**ADDENDUM NO. 1**  
**May 7, 2024**

**PROJECT: CITY OF SAN SABA  
 SIDEWALK IMPROVEMENTS**

**BID DATE: May 14, 2024**

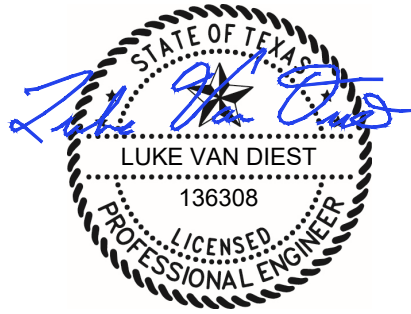
a) Relief joints shall be provided in concrete per the details below.

**NOTE:**  
 CONTROL JOINTS SHALL BE SAWN NOT LATER THAN THE FOLLOWING TABLE, OR 16 HOURS AFTER FINAL TROWELING (WHICHEVER IS LESS), WHERE TEMPERATURE EQUALS THE AMBIENT TEMPERATURE IN DEGREES FAHRENHEIT AT THE TIME OF FINAL TROWELING. SAWCUTTING SHALL BE SUSPENDED ONLY IF THE LARGE AGGREGATE IS DISLODGED OR LOOSENED. ALTERNATE: USE PRE-FORMED JOINT FORMER.

TEMP - °F	TIME - HOURS
< 40°	16
50°	14
60°	8 1/2
70°	5 1/2
80°	4
90°	3
